Description errors in the Report on the seismic safety assessment of unit 5 and unit 6 of Kashiwazaki-kariwa Nuclear Power Station

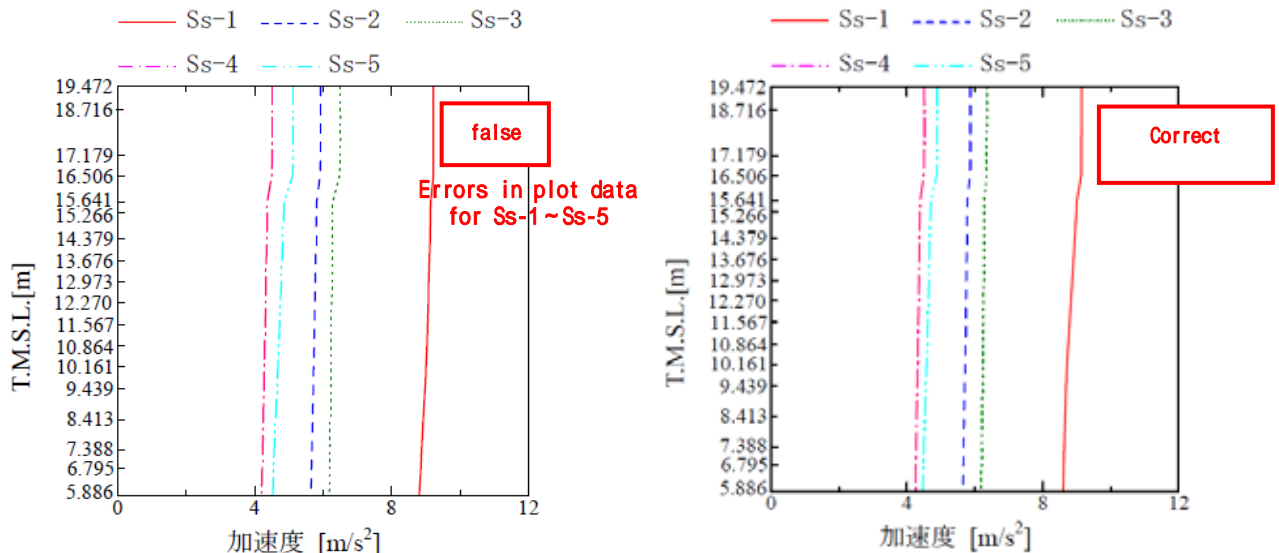
- Example of errors in the description of figures

The title of the figures was misstated as “core structure – horizontal direction maximum response acceleration spectrum (NS direction)” which was in correct description “core internals – horizontal direction maximum response acceleration spectrum (NS direction)”

(example : Unit 5 Kashiwazaki-Kariwa Nuclear Power Station Report on Seismic Safety Assessment (Equipments and piping systems))

参图-7.2.23 炉心シュラウド鉛直方向
最大応答加速度

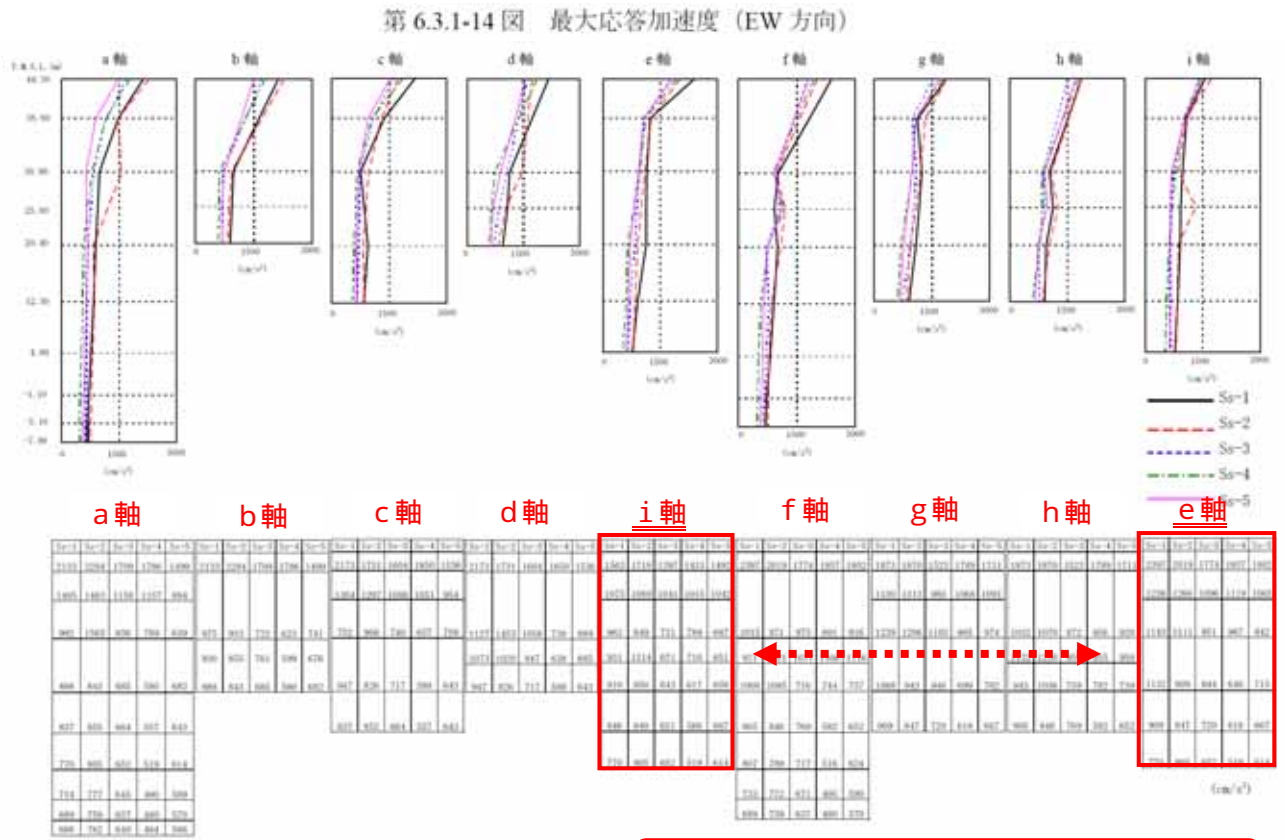
There were errors in plot data for the figures of “core shroud - vertical direction maximum response acceleration spectrum”. The figure was not used in the seismic safety assessment. (example : Unit 6 Kashiwazaki-Kariwa Nuclear Power Station Report on Seismic Safety Assessment (Equipments and piping systems))
